Date: March 4, 2021
To: Design Review Board
From: Tony Leavitt, Senior Planner
File No.: DRV19-00306
Subject: **KIRKLAND URBAN SOUTH (PHASE 2) PROJECT
MODIFICATION TO DRB DECISION**

DESIGN REVIEW BOARD DECISION

FILE NUMBER: DRV19-00306

PROJECT NAME: KIRKLAND URBAN SOUTH (PHASE 2) PROJECT

3. East Facade Blank Wall

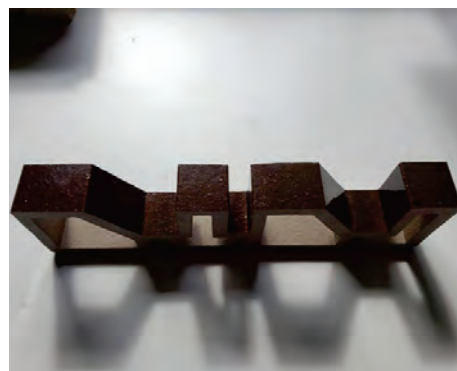
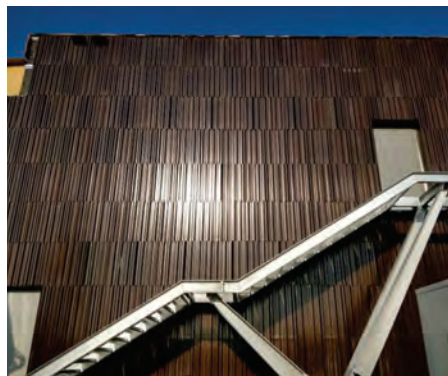
- Clearly identify materials to be used.
- Break up the scale of the upper wall with joints or other architectural elements

Lightstrips inserted

SKYBRIDGE DESIGN

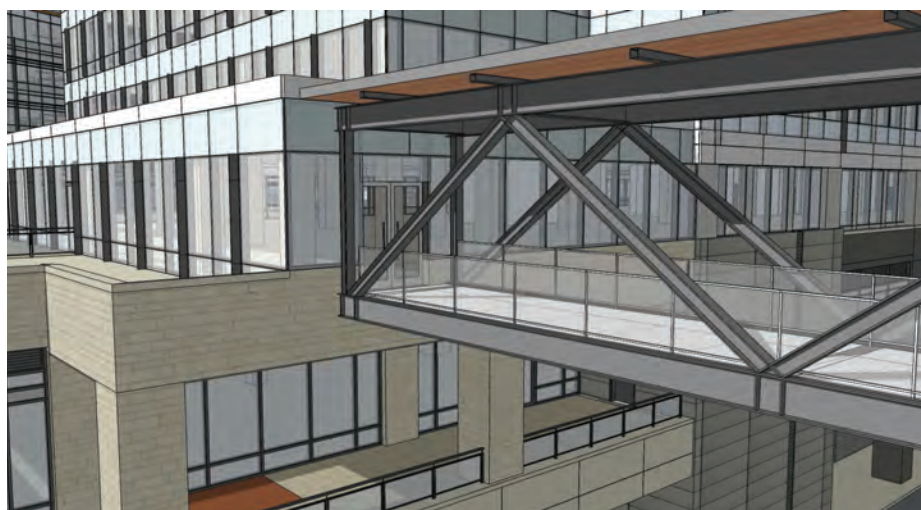
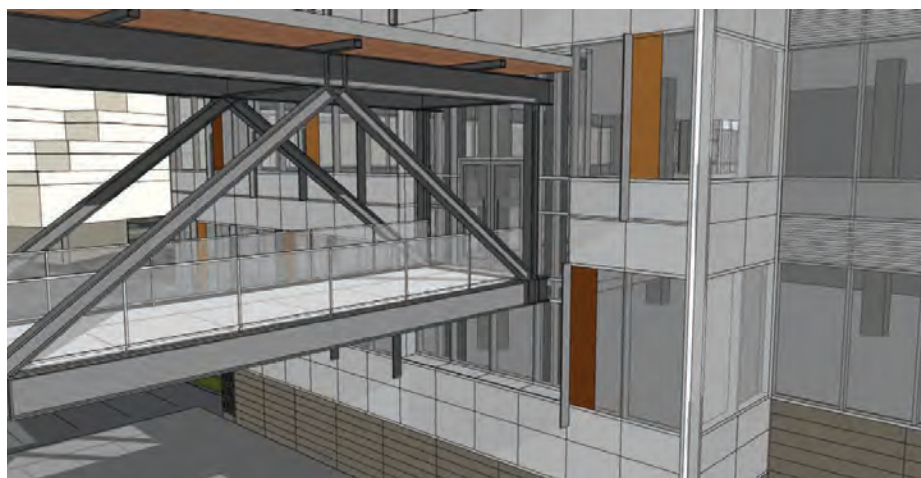
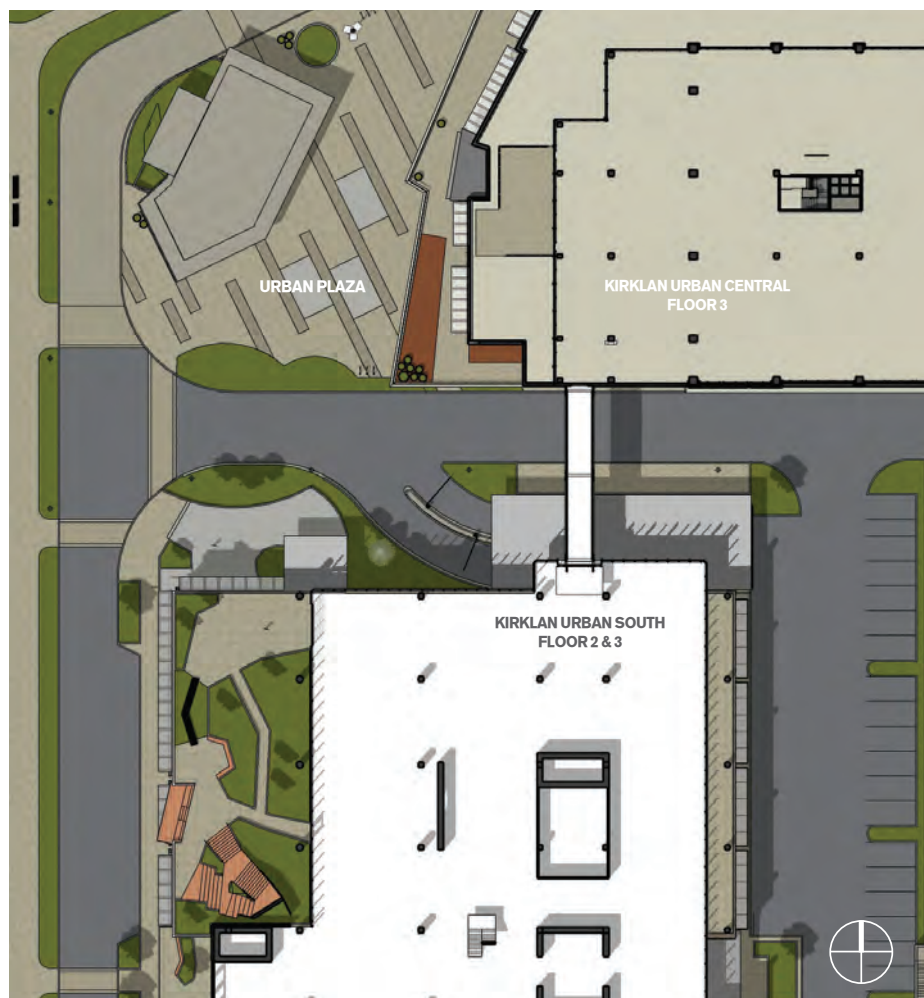
The DRB recognized the proposed skybridge's impact on public space. The Board asked the applicant to either move the skybridge to a less visible location or design the bridge with more sculptural expression in its current location.

The skybridge has been moved back away from the park edge and public plaza, significantly reducing its span between the buildings. The design has been kept modest, blending in with the existing buildings.

Thought has been given to how it intersects each building on the ends, lining up with existing material lines on the Central building, and landing in a small notch on the South building.

Level 1.5 Floor Plan
SCALE: 1" = 40'-0"

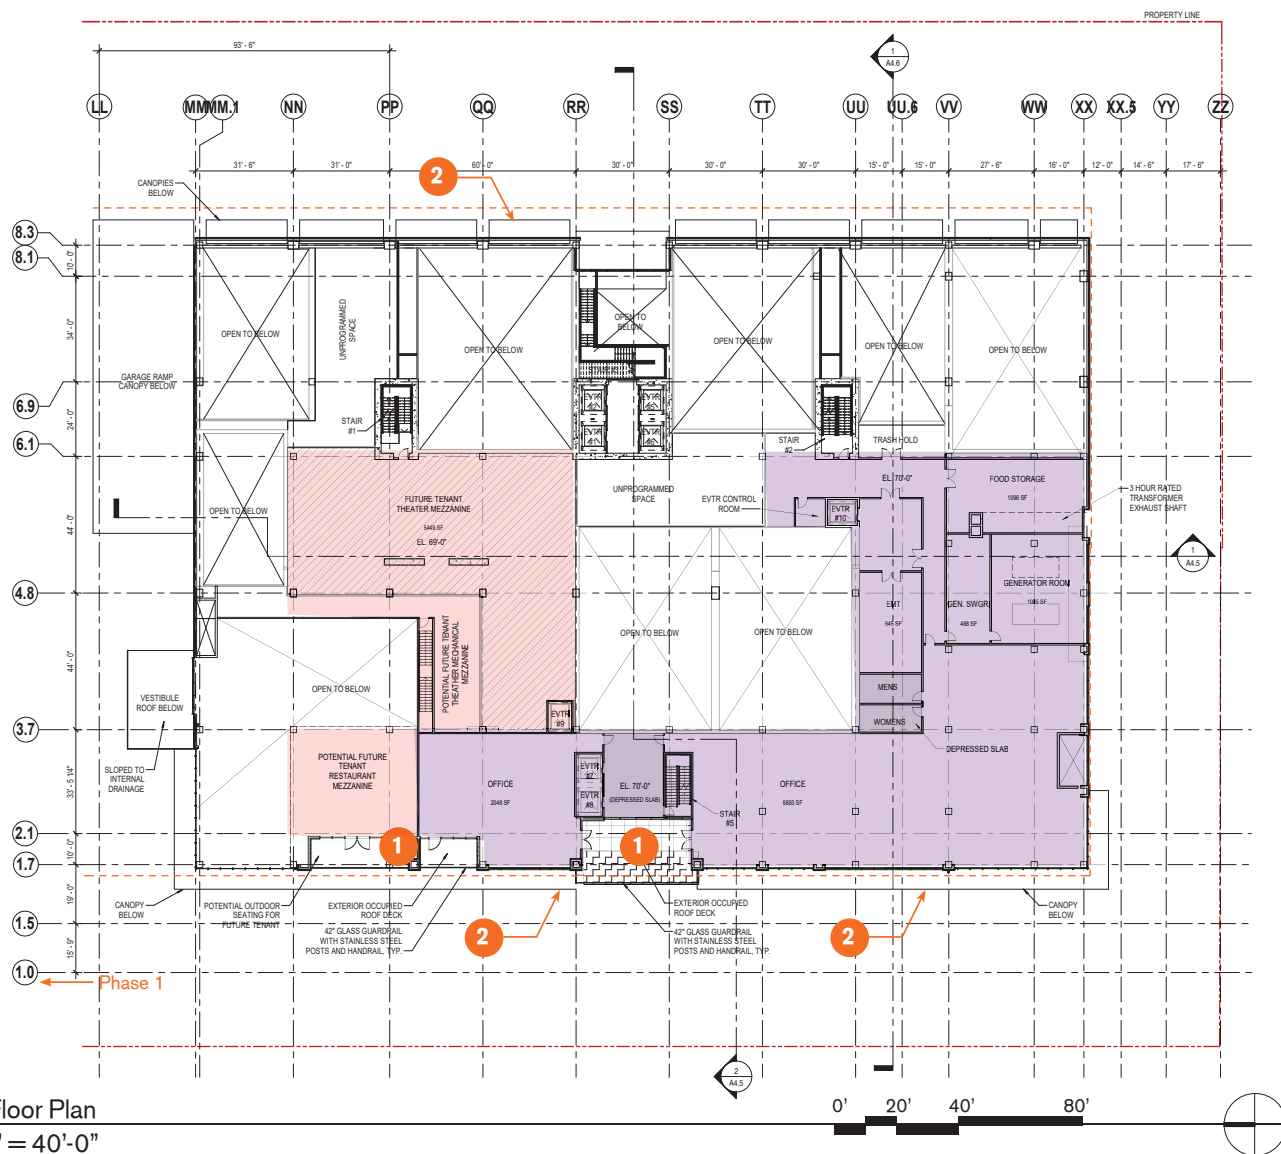
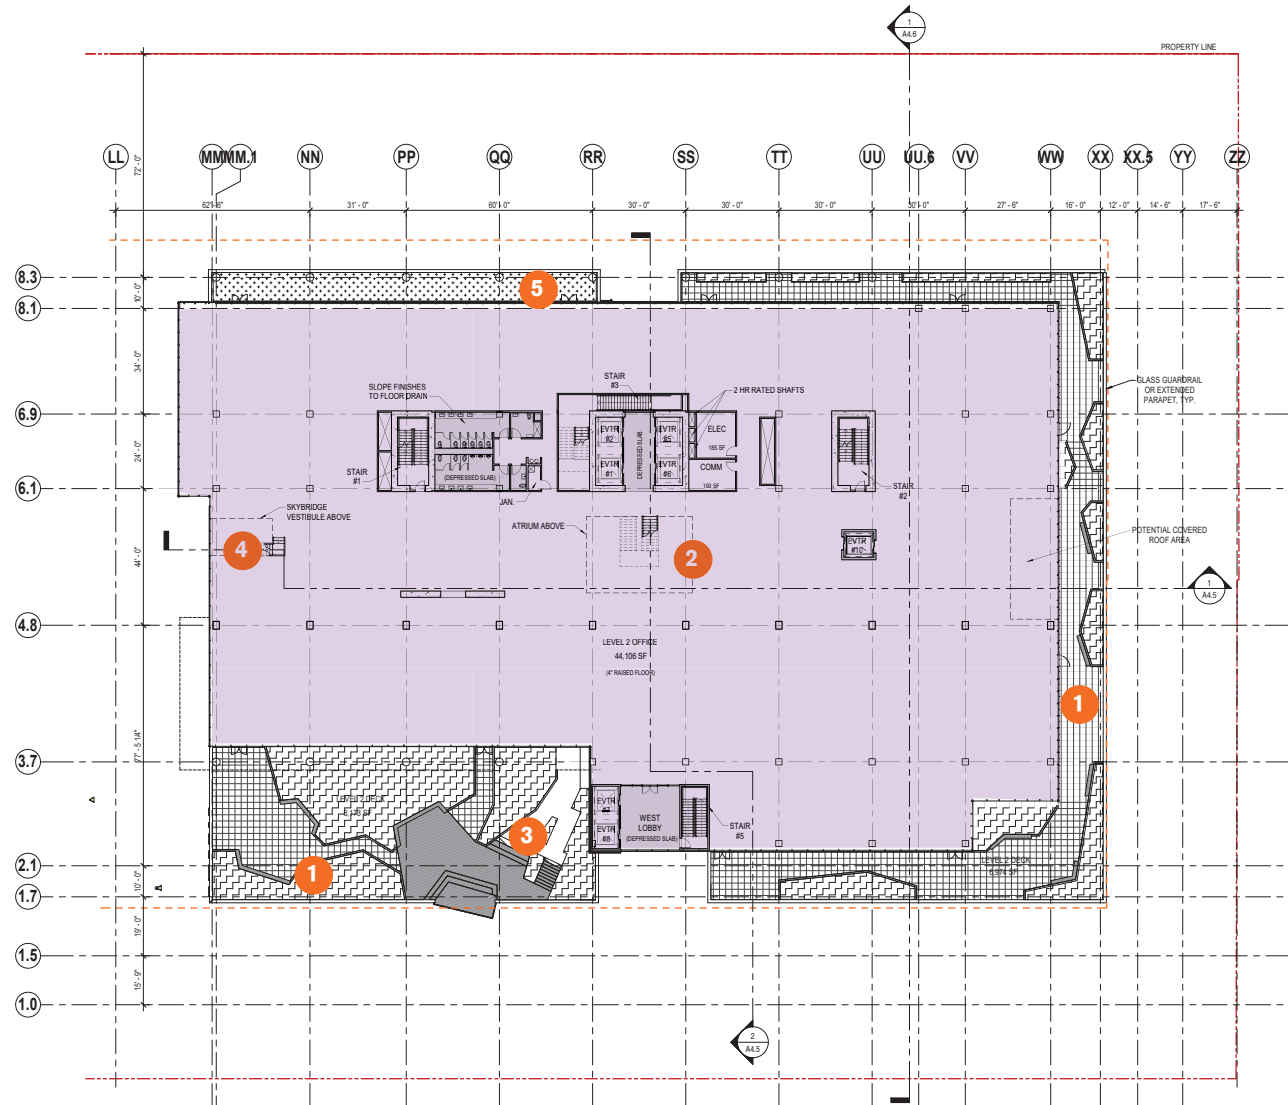
The applicant has outlined the reasons for the requested modification in Attachment 3. The proposed changes are to the design of the L1 and L1.5 retail areas that will provide flexibility and amenity space for potential retail tenants (see Attachment 4). The proposal includes cutting back the northwest corner of L1.5 and expanding the deck level. The proposed scheme also has the deck overhanging the west edge of the building by 8 feet which results in a 6.33 foot encroachment in to the 55 foot Peter Kirk Park setback.

In general, we are proposing cutting back the NW corner of L1.5 and expanding the deck at that level substantially. We believe this change maintains many of the design elements the DRB liked about the building, while adding an additional level of activation at the most public-facing corner of the building. If you recall, one of the major comments we worked through with the DRB was in regards to having these decks engage the public at lower levels, and we believe the revised proposal achieves this goal even better than the original design. The proposed scheme also has the deck overhanging the west edge of the building by 8'-0" (a 6'-4" encroachment into the 55' setback from Peter Kirk Park), similar to the canopies previously approved by the DRB as a minor modification. We would need to know how to address this additional minor modification to setback requirements.

- A. The proposed modifications shown in Attachment 4 are supported by staff and will help to activate the northwest corner of the building with an expanded deck on Level 1.5. The changes were found to be consistent with the general design principles approved by the Board. Does the DRB have any additional comments on the proposed modifications?
- B. Is the proposed deck setback encroachment comparable to the approved minor variation for the canopies?

Level 1 - Required Overhead Weather Protection

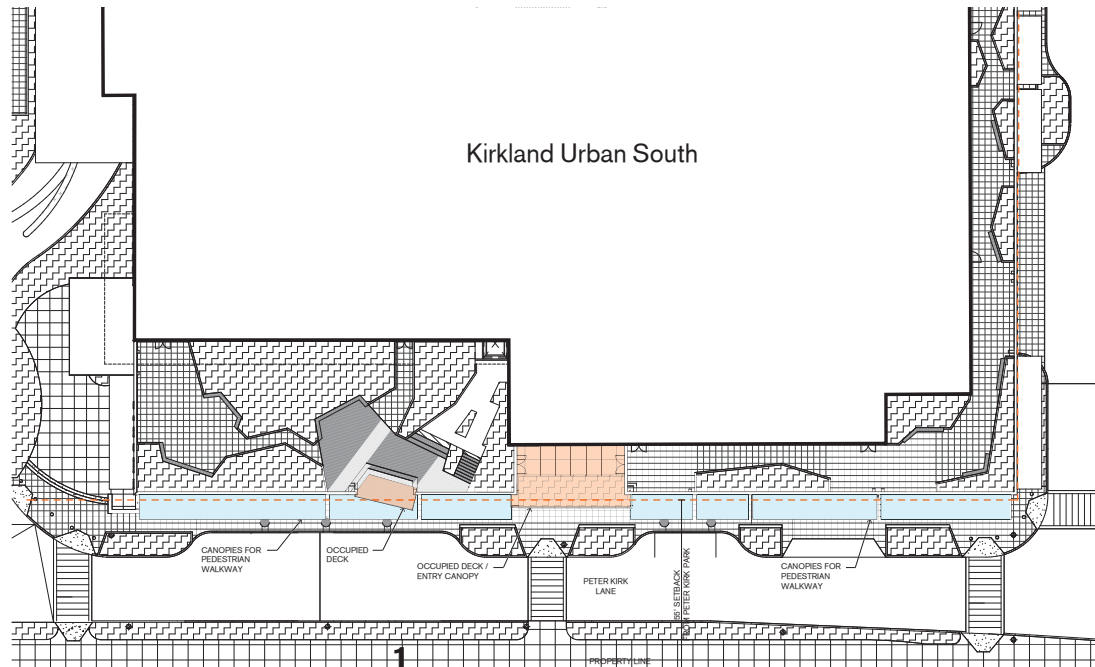
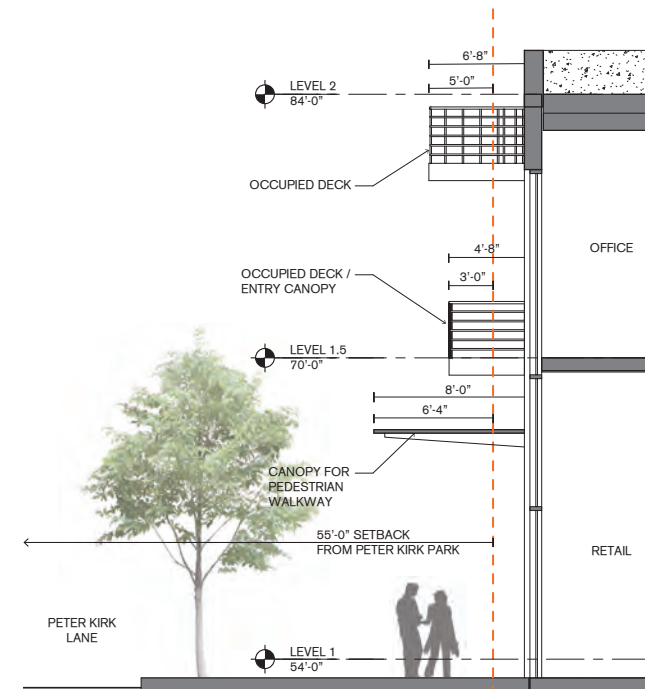
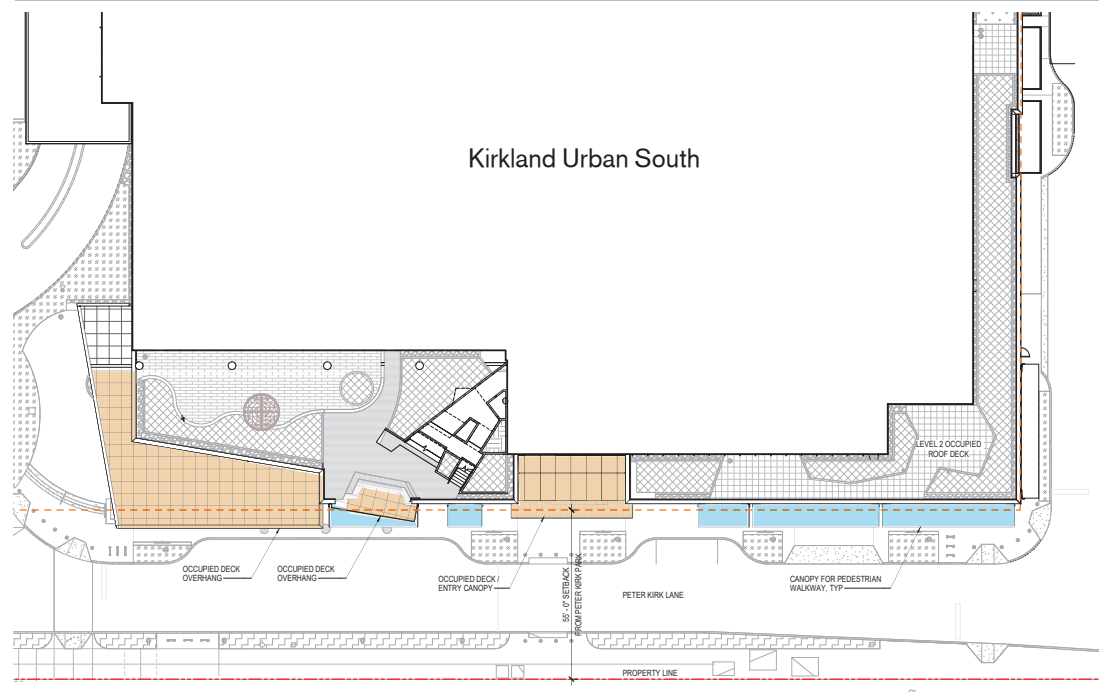
- 1 A minor modification to the 55 foot setback from Peter Kirk Park is requested for canopies and occupied decks that will project from the building face more than the 18 inches allowed per Section 115.115. 3.d. of the Kirkland Zoning Code.

The Master Plan and Design Guidelines encourage canopies at Retail frontage and at Pedestrian Pathways, and are noted in the Master Plan and Design Guidelines for the street section on Peter Kirk Lane (Park Promenade). The canopy at the main elevator lobby also doubles as an occupied deck at Level 1.5, responding to the Board's recommendation that the upper level decks occur at a level lower than the 30 foot tall building base. Another projecting deck at Level two serves to extend the activity of the Level two decks out towards the park, and is lowered to create better views both to and from the park. It aligns with the feature stair connecting decks at levels two and three, and provides additional articulation in the podium.
